Tahmoor South Project

Amended Project - Noise and Vibration Impact Assessment

Prepared for Tahmoor Coal Pty Ltd
February 2020

H180165 RP2

Noise Modelling - source locations

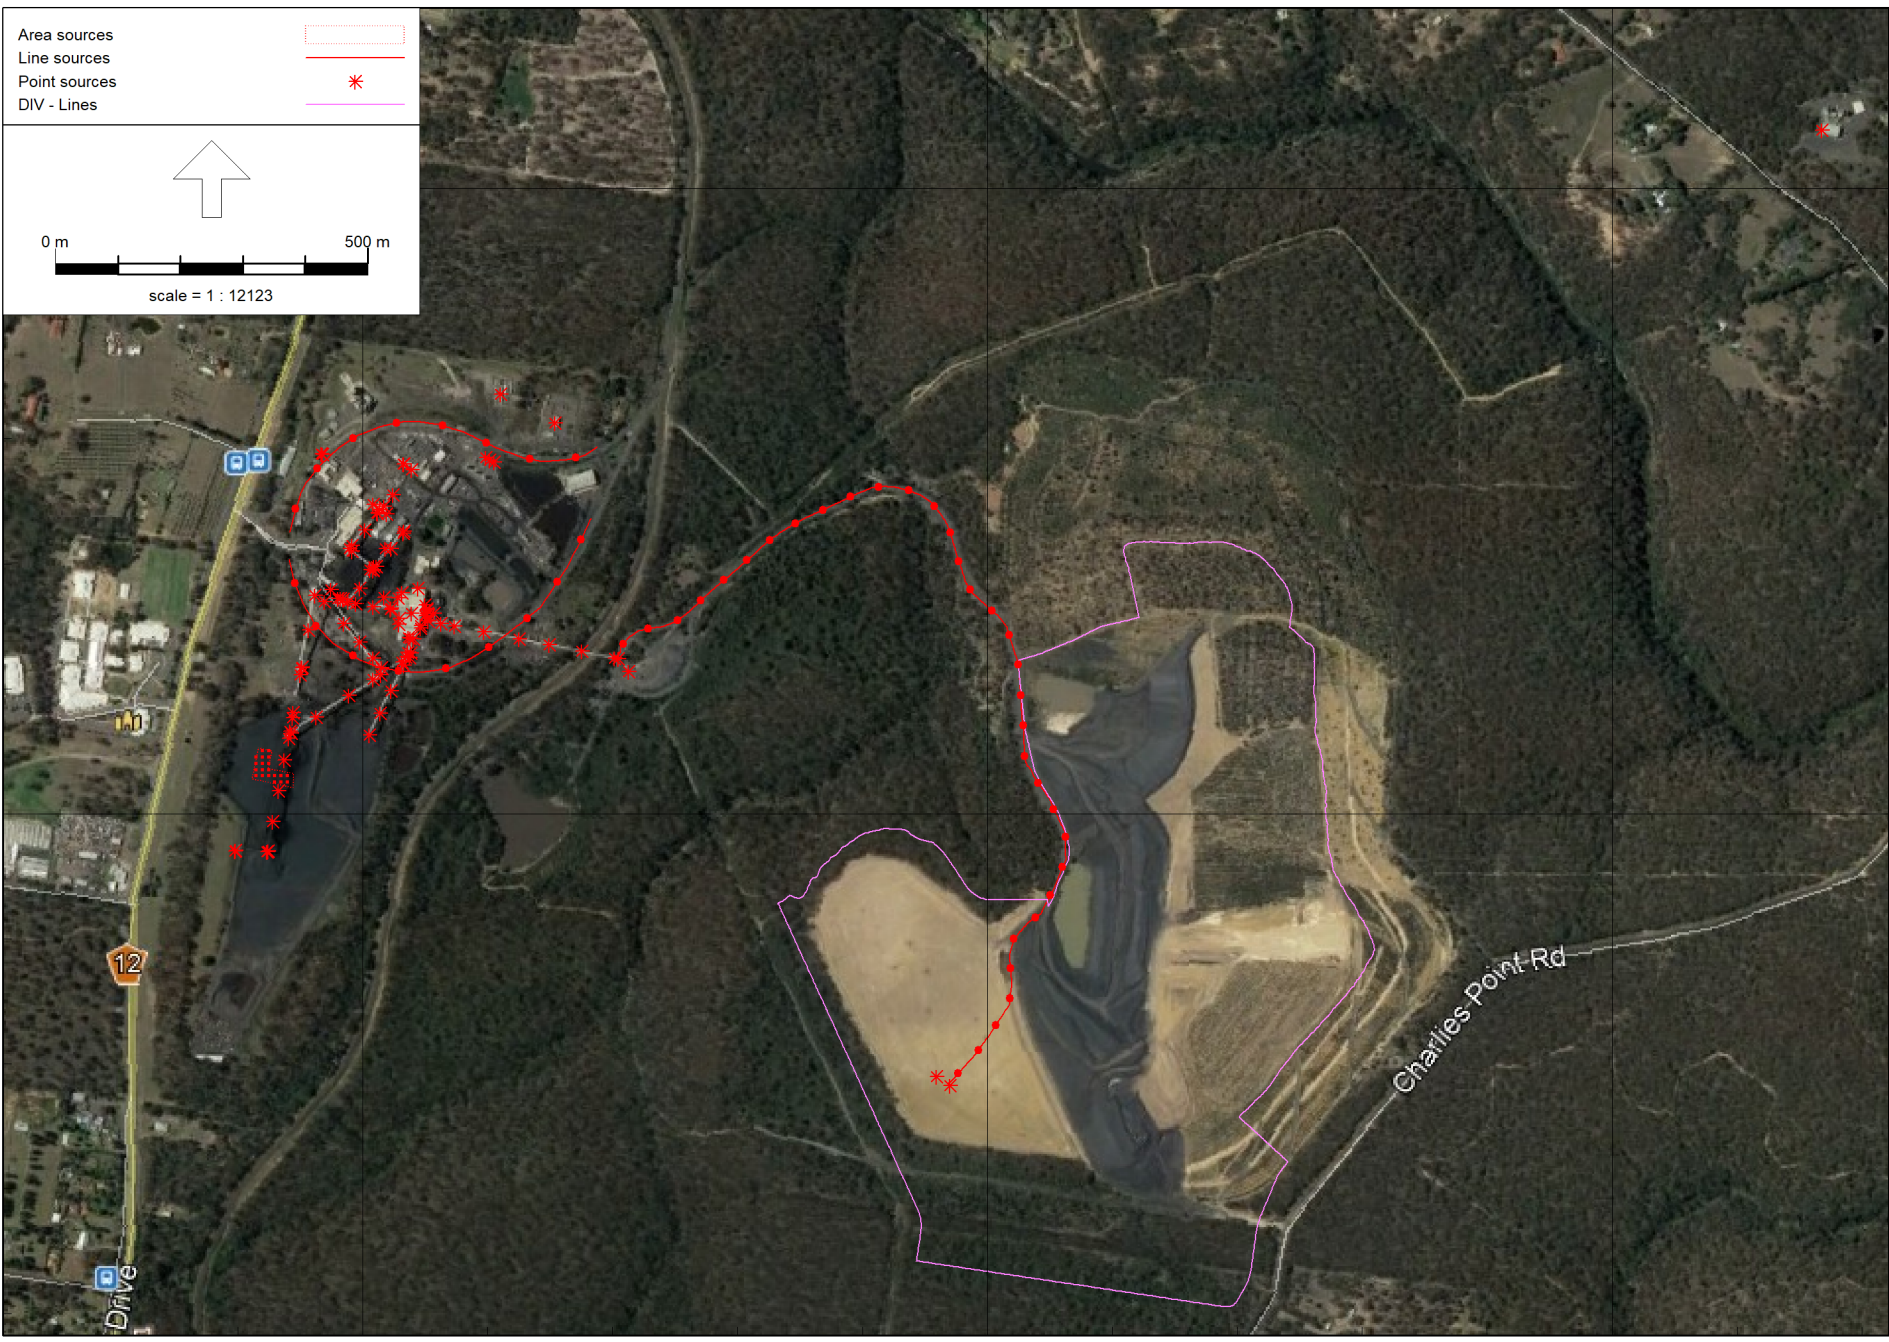
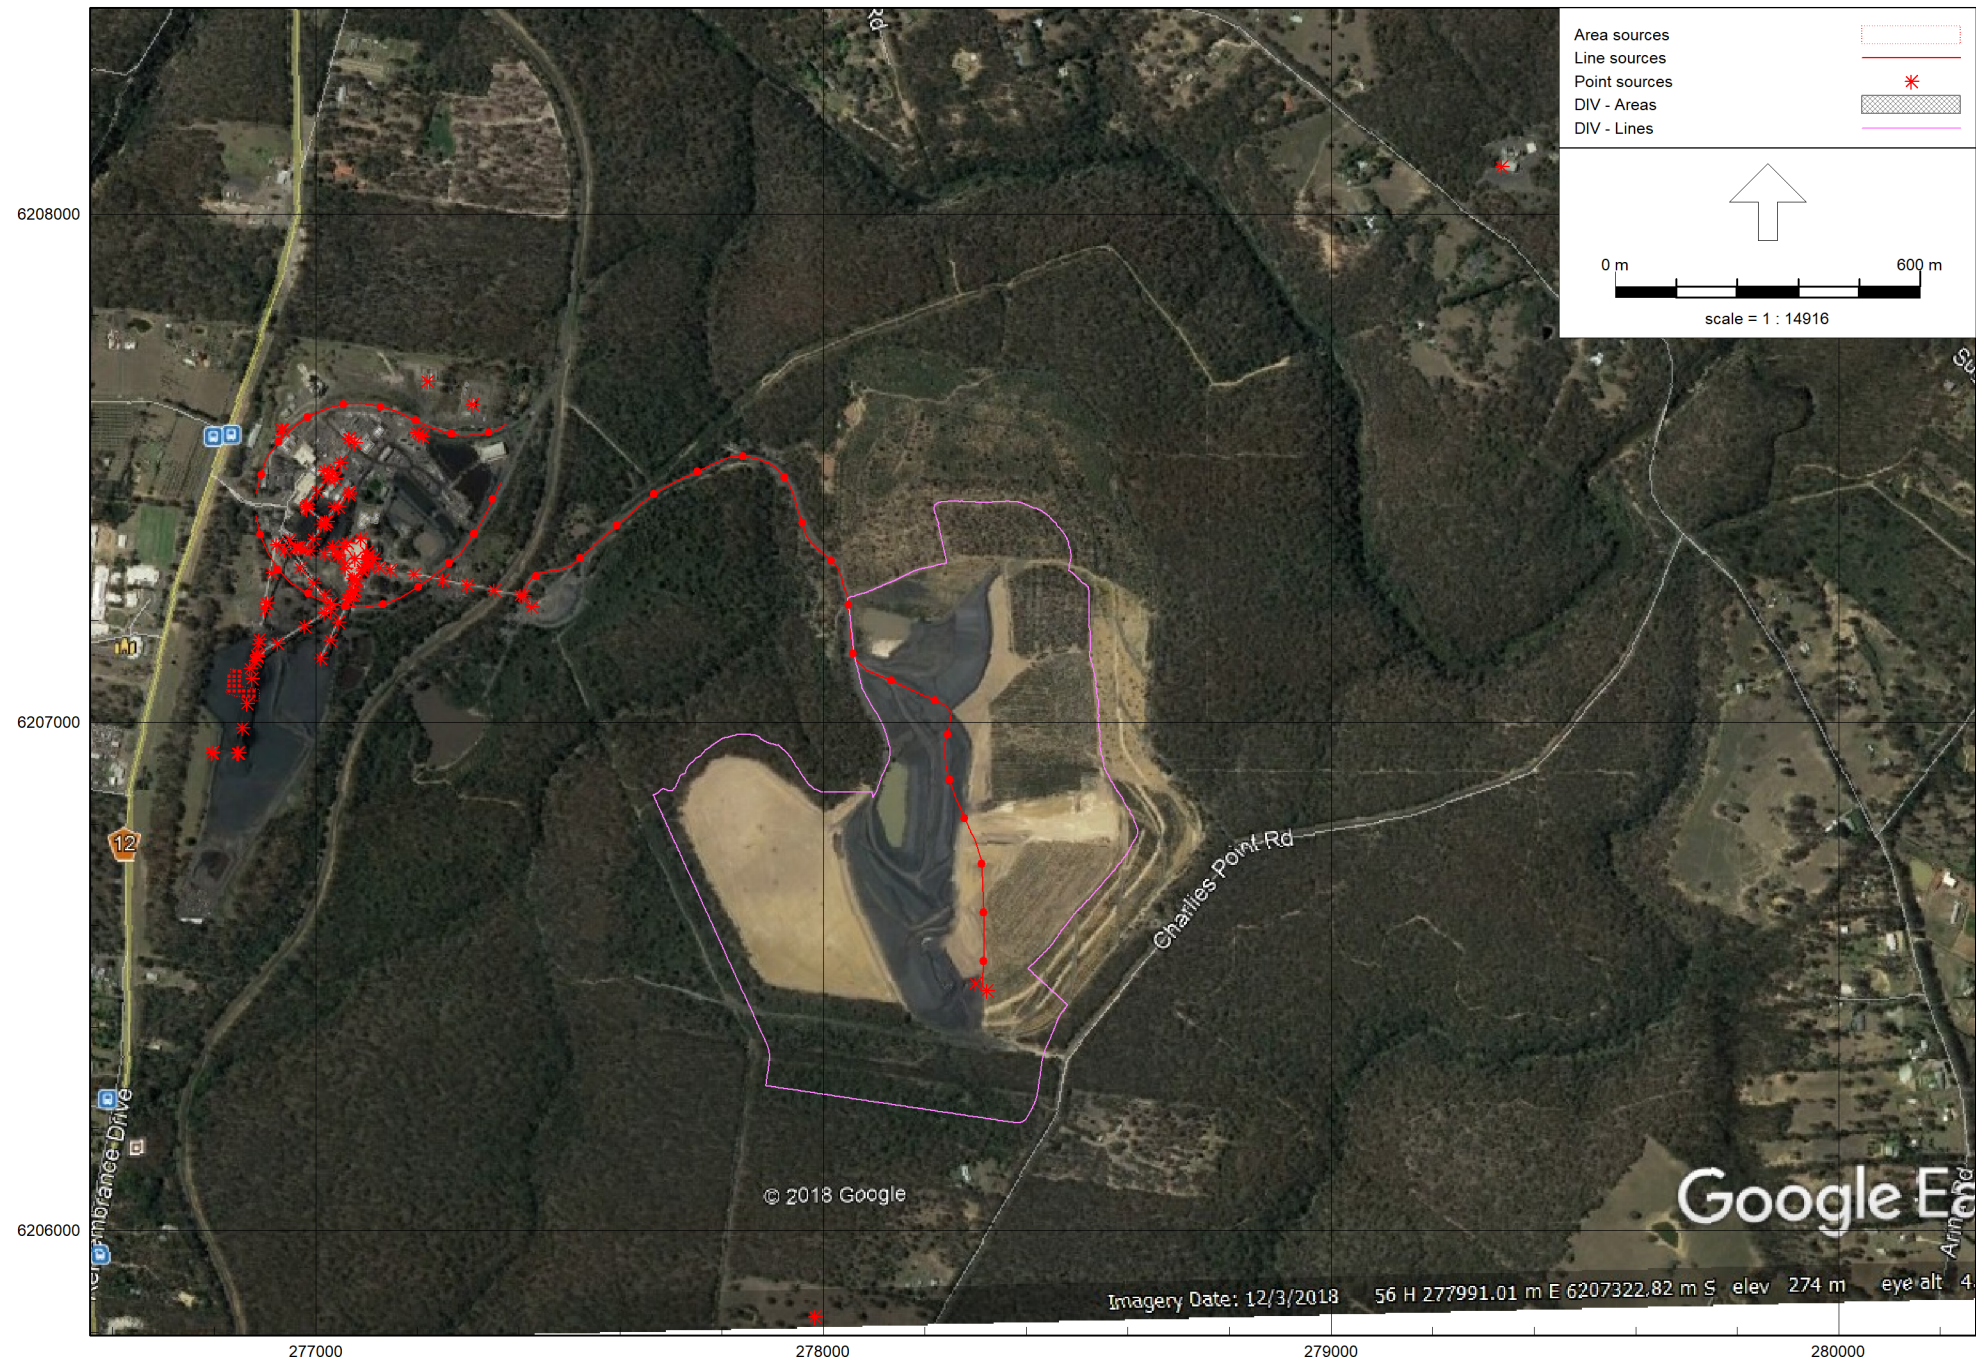
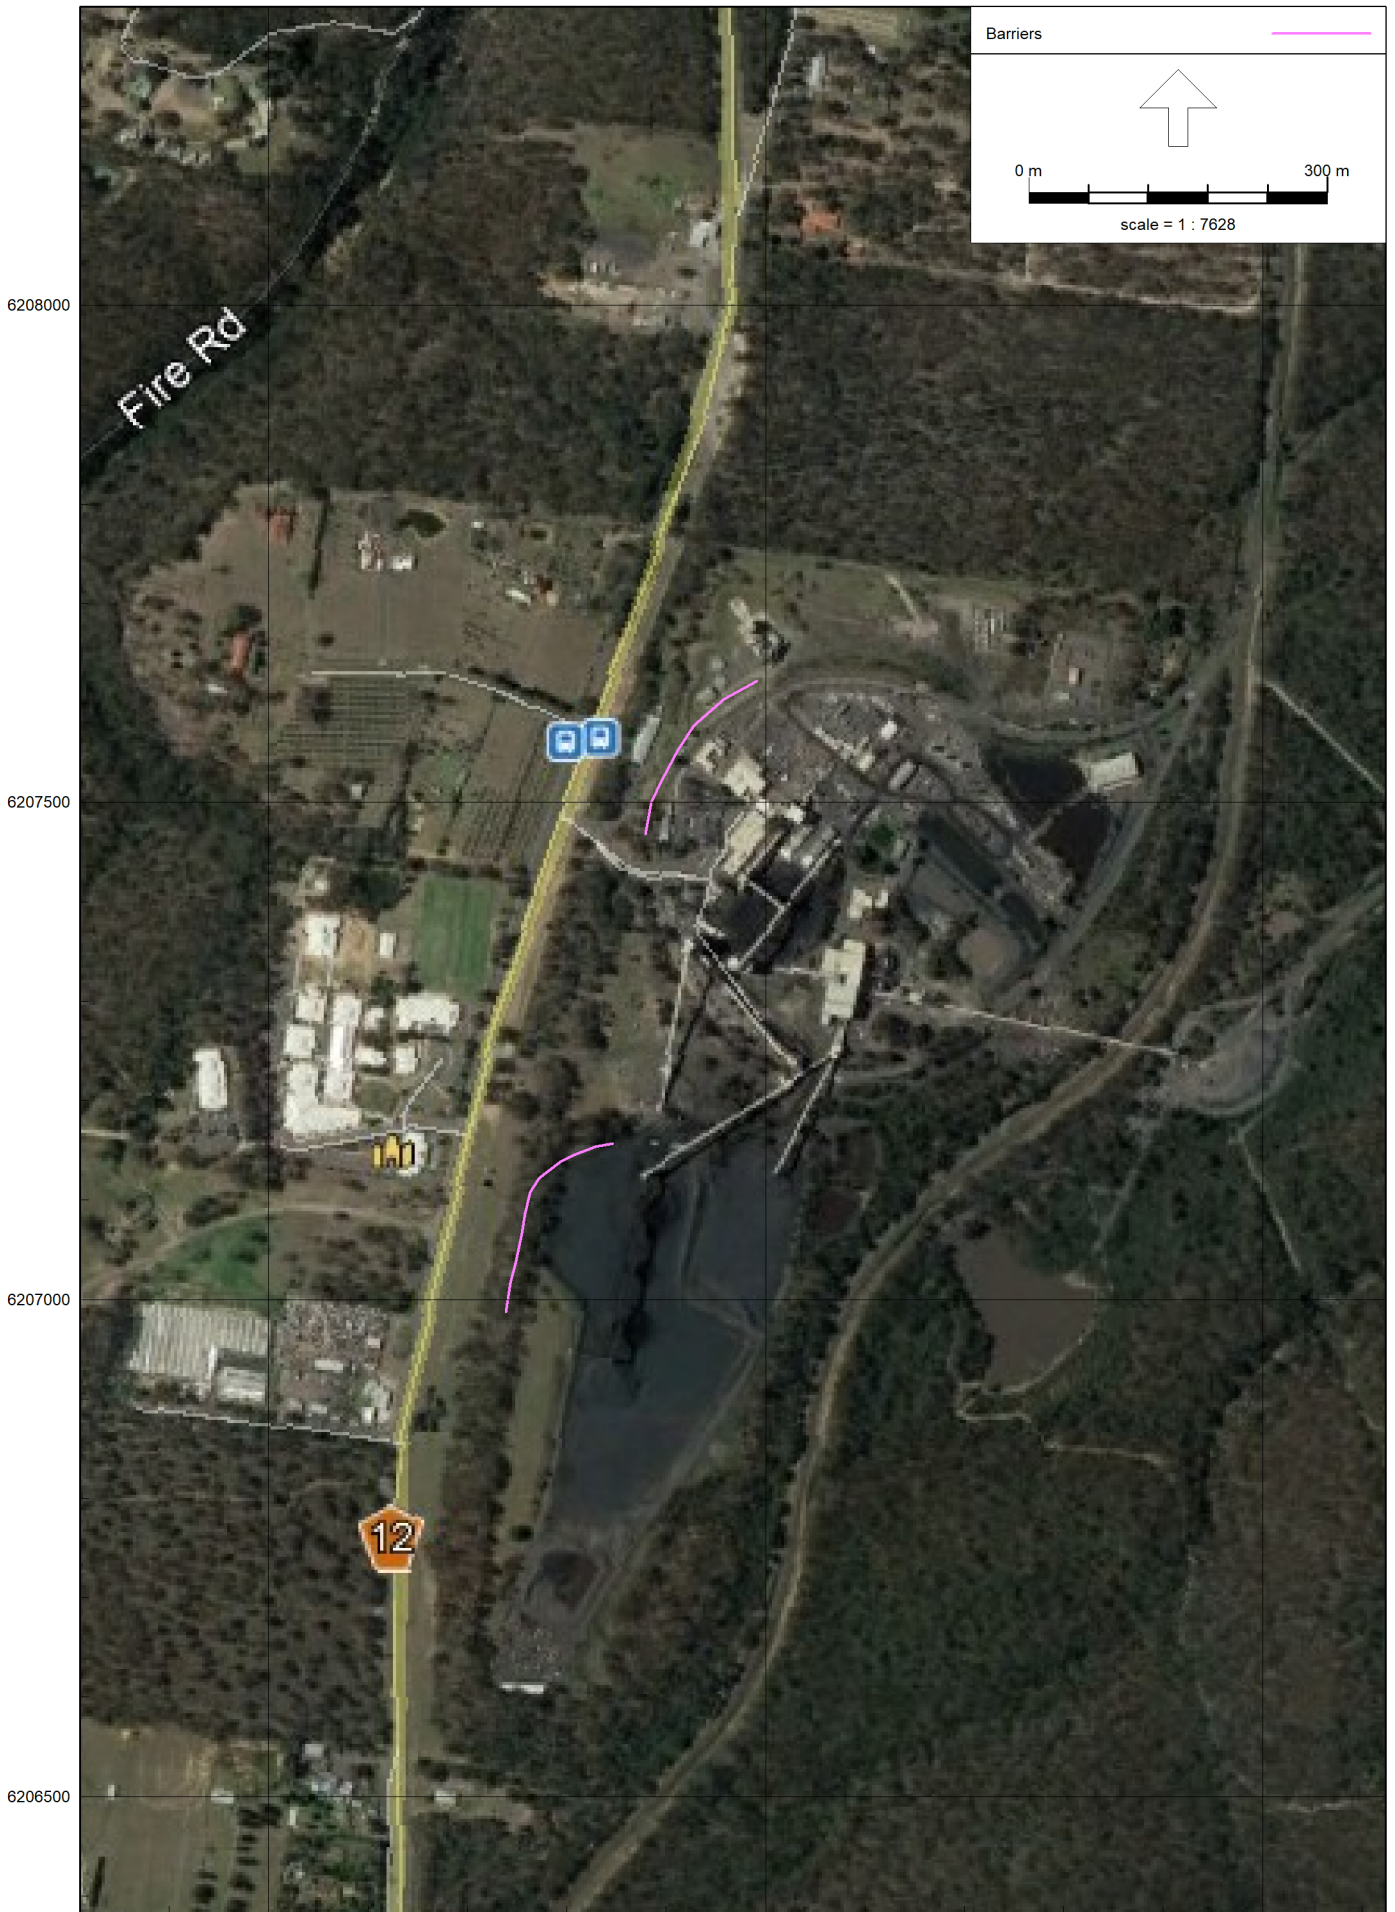
7	Appendix B noise source modelling maps should be accurately labelled to identify equipment and the dozers and on-site haul trucks moving on and between the stockpiles (product and ROM). This should be included in the revised model to derive a worst-case scenario at receivers.	As for EPA submission Point 4, the use of haul trucks to move product and run-of-mine (ROM) coal instead of conveyors is not proposed.	Section 6 and Appendix D
